**Consultation Response from KC,
Highways Development Management****2026/92204 4, Back Lane, Grange Moor, Huddersfield, WF4 4EJ****Demolition of existing dwelling and garage and erection of 8 dwellings with associated works****Date Responded: 9 September 2026****Responding Officer: Sheila Henley****Responding Ref: 16-6/32****Recommendation: Further information and revisions.**

Plan ref: 2583-D-20-003 Proposed Site Plan Rev A; 2583-D-20-008 Garage Type 01
Reference to planning approval: 2022/92428.

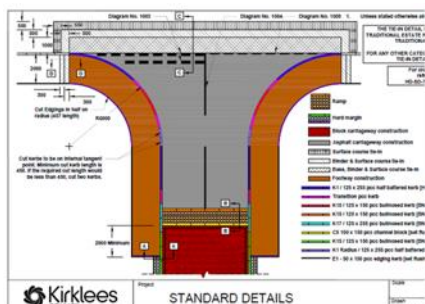
The proposed private drive access is indicated with c4.5m width and kerb radii c4m. This will need to be amended to allow footway access into the site for the first 8.0m as shown below and not just to the rear of the footway as indicated below. A minimum carriageway width of 5.5m is necessary for the first 5.0m of the private drive to better cater for two-way movements and shared use between pedestrians and vehicles

Bin collection points will be required where dwellings are located further than 25.0m from the adopted highway. The current location would fall in the location of the extended footways as indicated on the layout above and below and will require repositioning.
